Hi-Fi Products
Service Bulletin

Model: CDP-C401/500

No. 92

Subject: No Tray Operation

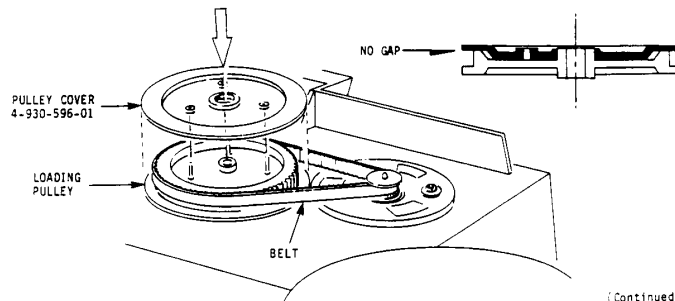
Tray does not open. The loading belt has slipped off.

1. Remove bottom panel.
2. Re-install belt.
3. Install Pulley Cover on the Loading Pulley.
